**TOWNSHIP OF NORTH DUMFRIES
BUILDING DEPARTMENT**

These Plans have been examined for Compliance with the Ontario Building Code requirements. A Building Permit has been Issued, subject to any changes noted, under the condition that the building will be constructed in accordance with the code.

**Tice River Homes
Legacy**

model
SD-01

A1

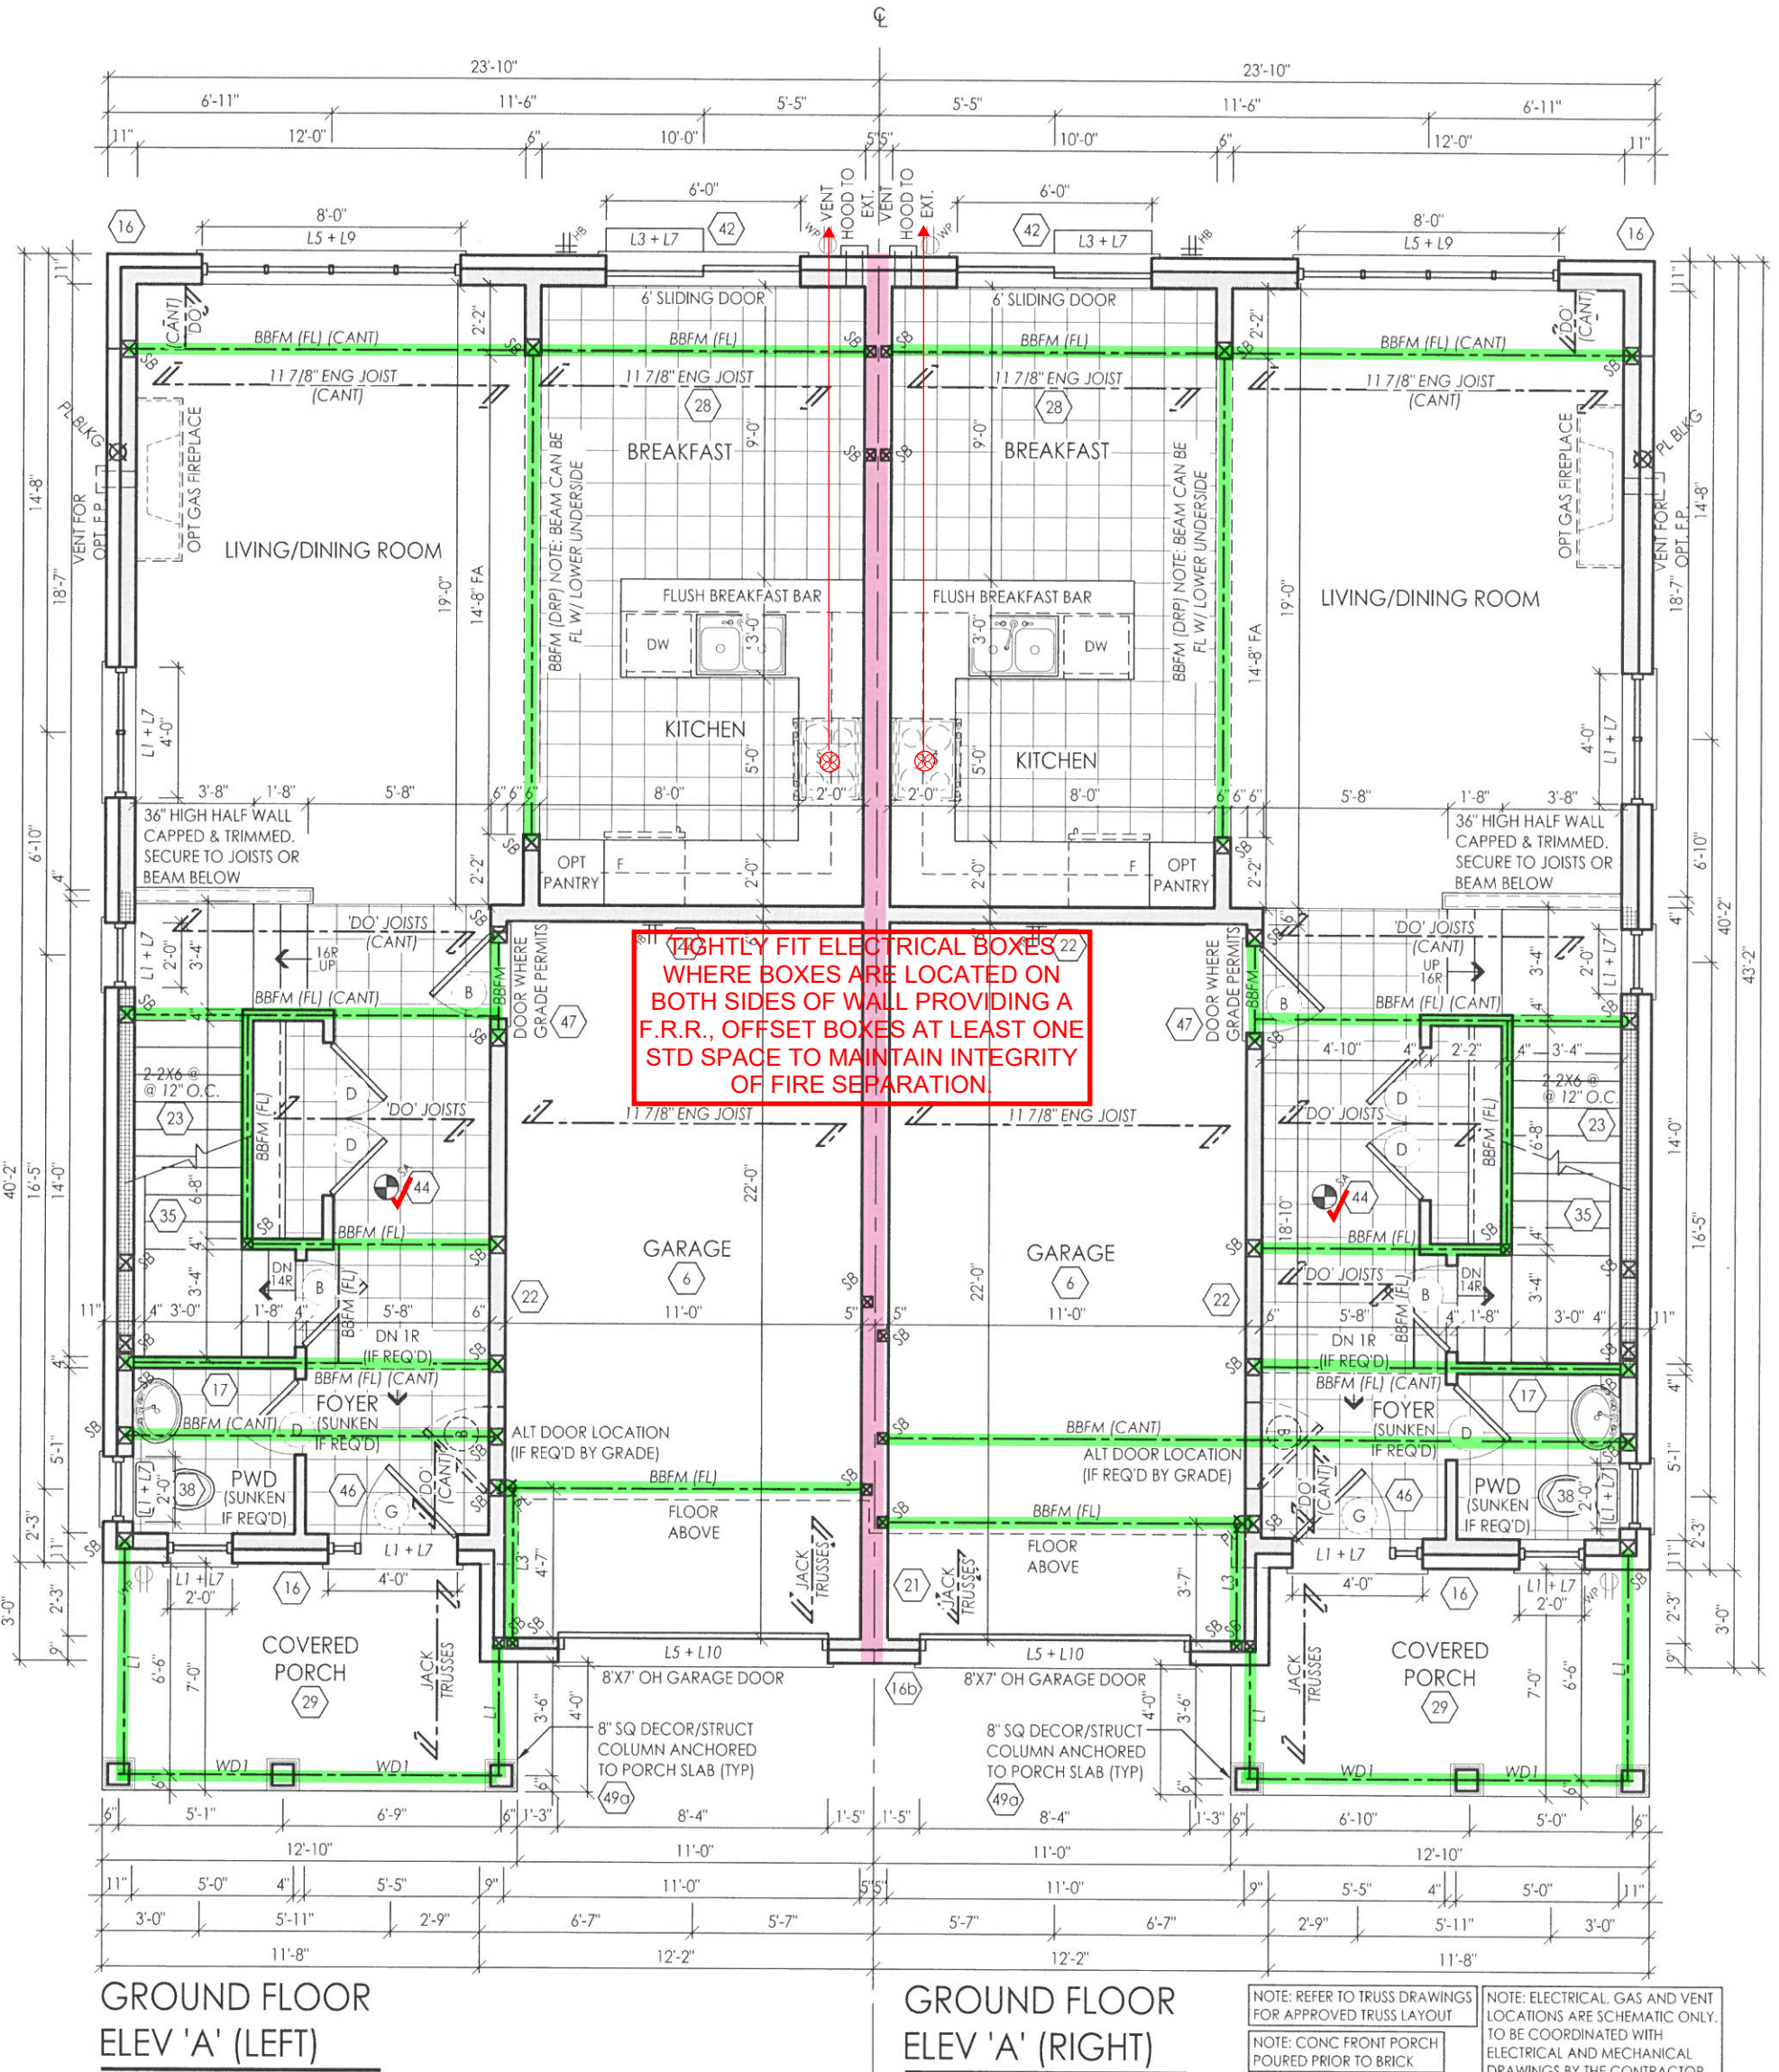
INSULATION IS REQ'D TO BE CONTINUOUS.

A SEPARATE BUILDING PERMIT WILL BE REQUIRED TO FINISH THE BASEMENT.

SUMP PUMP LIDS, JOINTS AT INTERSECTIONS & ALL PENETRATIONS OF SLAB MUST BE SEALED TO PREVENT AIR LEAKAGE.

THE COLD CELLAR DOOR NEEDS TO BE INSULATED AND WEATHER-STRIPPED.

page
A3

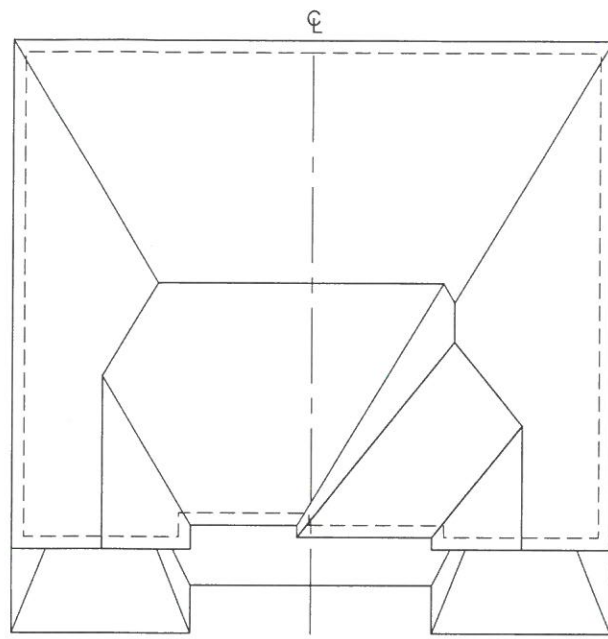
REINFORCEMENT REQUIRED IN MAIN BATHROOM STUD WALLS TO PERMIT THE FUTURE INSTALLATION OF GRAB BARS.

NON CONBUSTABLE CLADING REQ'D
